Modification to run CPU09CMI on 3MHz bus.

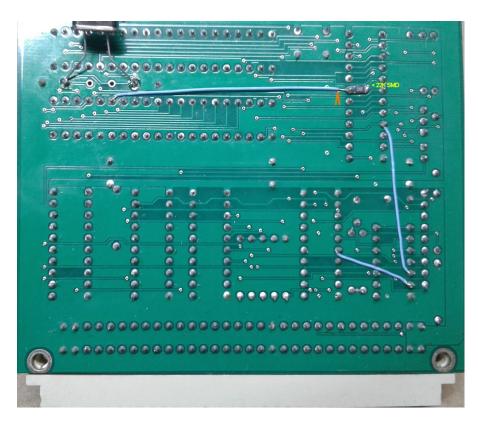
Replace xtal into 12MHz Replace GAL CMI_1 by CMI-4_1 Only use the HD63C09.

On solder side:

Cut trace between U13-19 and via (OVMA) Place 22K resistor between U13-19 and Gnd

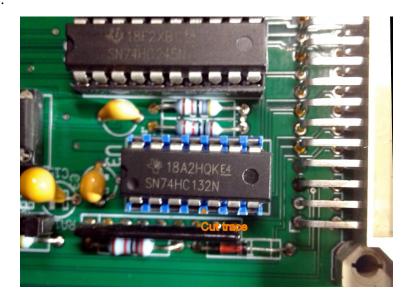
To keep CPUxxCMI 6802 compatible:

On top side:

Cut trace between U3-4 and U3-5

On solder side:

Place wire from U3-5 to U13-9 Place wire from U3-6 to U4-6
